# 950 NE Pollard St Rezoning from CP-2 to PI and Preliminary Development Plan

PL2022-159

July 26, 2022

## Sidewalks

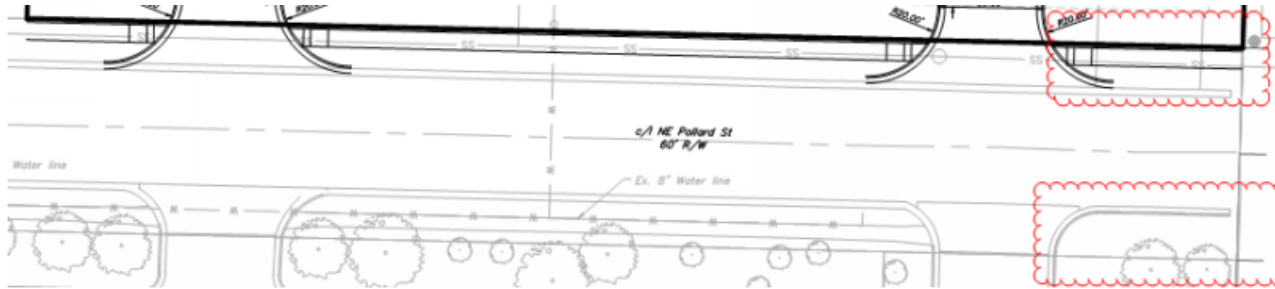
- Request - A modification to seek relief from both the requirement to construct a 5' sidewalk from the east driveway to the east property line and the requirement for payment in lieu of construction for said ~54'-long sidewalk segment.
- Recommendation – Staff supports the modification request to not require construction the easternmost sidewalk segment, but does not support waiving the payment in lieu of construction.

1. A modification shall be granted to the requirement for a sidewalk along the entire street frontage along a commercial or industrial street, to not require construction of the sidewalk segment (approximately 54' in length) east of the easternmost driveway serving the site. Payment in lieu of construction for said segment shall be required.
